Safety Notice <i>Mandatory Action Required</i>	170019

Models Affected: S-100/S-105
S-120/S-125
S-100HD

Subject: Machine Unladen Weight

- 1 Serial Number Label (under the covers)
- 2 Serial number (stamped on chassis)

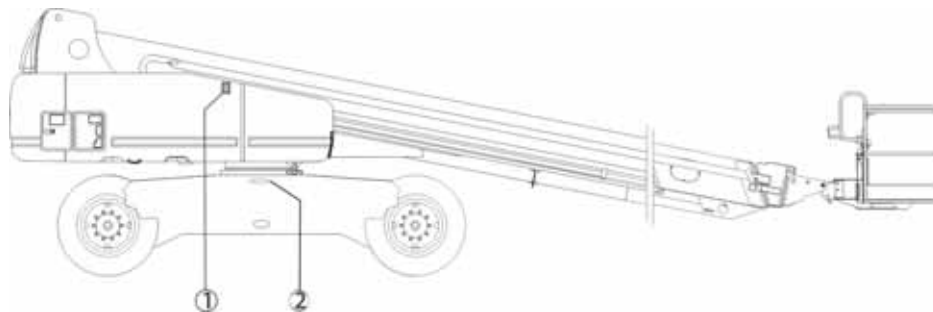
- 1 Verify that the Serial Number printed on the "Serial Number Label" is the same number stamped on the machine. Refer to illustration 1 for the location of the "Serial Number Label" and stamping on the machine.

- 3 Locate, remove and destroy the "Serial Number Label" attached to the machine.
- 4 Using the cleaning solvent or degreaser, thoroughly clean the surface where the "Serial Number Label" from step 3 was removed. Touch up paint as needed. Allow the surface to dry.

- 5 Apply the provided "Serial Number Label" on the area in step 4 carefully, making sure that air bubbles are eliminated. Use the squeegee to remove trapped air.

- 6 Apply the protective overlay film carefully making sure that air bubbles are eliminated. Use the squeegee to remove trapped air.
- 7 Fill out and sign the attached completion form and fax or email to Terex AWP Warranty Department. This will serve as verification that you have completed Safety Notice 170019.
